適航指令發布單
Airworthiness Directive Issuance Form

民航局 AD 編號 AD number	CAA-2021-11-004 緊急	發布日期 Date issued	2021/11/5												
適用之航空產品 Applied to (models, serial numbers or part numbers, as applicable)	Fuel cylinders Part No (P/N) CB2901, P/N CB2902 and P/N CB2903, having a serial number (s/n) as listed in Appendix 1 of this AD, where the cylinder is equipped with a QSO valve (incorporating flanged adaptor P/N CB437 Issue F), and all P/N CB2901, P/N CB2902 and P/N CB2903 cylinders having a s/n not listed in Appendix 1 of this AD that have been fitted with a flanged adaptor P/N CB437 Issue F and released as spare parts under Invoice and Form 1 Numbers as listed in Appendix 2 of this AD. Stainless Steel cylinders CB426, CB497, CB599, CB959, CB2088, V20, V30, V40; Titanium cylinders CB2380, CB2383, CB2385, CB2387, T30 (CY-050-A-001) and "Worthington" Aluminium cylinders CB250, may also be affected if fitted with CB437 flanged adaptors supplied on invoice and Form 1 numbers listed in Appendix 2 of this AD. These fuel cylinders are known to be installed on, but not limited to, hot air balloons and airships manufactured by Cameron Balloons Ltd, Colt Balloons, Lindstrand Balloons Ltd (LBL),

Figure 1: *CB437 Flanged Adaptors for Quick Shut-Off (QSO) valves*

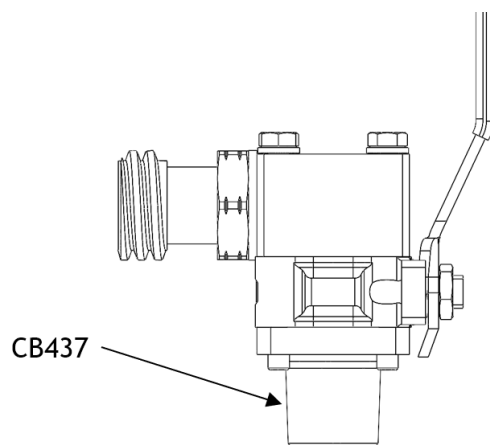
Certain Cameron Hot Air Balloon fuel cylinders are supplied with liquid offtakes that consist of a quarter turn ball valve mounted on a flanged adaptor (P/N CB437, see figure 1). Two recent batches of these adaptors have been manufactured with non-conforming (undersize) threads.

In certain cases, when the minimum sized adaptors are combined with cylinder bosses at maximum tolerance dimension and assembled to fuel cylinders, the thread can impinge (“bottom out”) on the cylinder boss. Although the required tightening torque value can be achieved at installation, the torque required to unscrew the flange could be below the minimum value. In extreme cases the adaptor may be unscrewed by hand.

This condition, if not detected and corrected, could result in an uncontrolled release of liquid propane which in turn could result in a fire hazard that could damage the balloon and its envelope, ultimately leading to a forced emergency landing, during which balloon occupants and persons on the ground could be injured.

1. From the 04 October 2021 (the effective date of AD 2021-0010-E), before further flight, inspect each fuel cylinder where an affected part is fitted in accordance with the instructions in section 5 of the SB for leakage around the threaded joint between the QSO valve adaptor flange and the cylinder boss.

2. If, during the inspection as required by paragraph 1 of this AD, any leakage is detected, before next flight, remove the cylinder from service in accordance with the instructions of the SB.

3. If no leakage is detected, cylinders may be subject to a torque test. Satisfactory completion of the torque test allows the return of the cylinder to service until 31/01/2022, then final rectification action must be applied to all affected cylinders as per section 5 below. The torque test must be carried out by a Part-66(or appropriately qualified) inspector. Details of the torque test are included in document CBL/TN/DCB/3287 (**See Reference Publications below**).

Cylinders that fail the torque check may be returned to service by replacing the QSO valve with a handwheel valve, P/N CB0824-0001, which has a Rego-type hose connection.

4. From the 04 October 2021 (the effective date of AD 2021-0010-E), do not install an affected part on any cylinder.
5. Within 4 months after 04 October 2021 (the effective date of AD 2021-0010-E), modify each cylinder by replacing the P/N CB437 issue F QSO flanged Adaptor, with a P/N CB437 issue G (or later issue) QSO flanged adaptor in accordance with the instructions of the SB, or by replacing the QSO valve assembly with a handwheel valve part No CB0824-0001 (this part has a Rego-type hose connection).
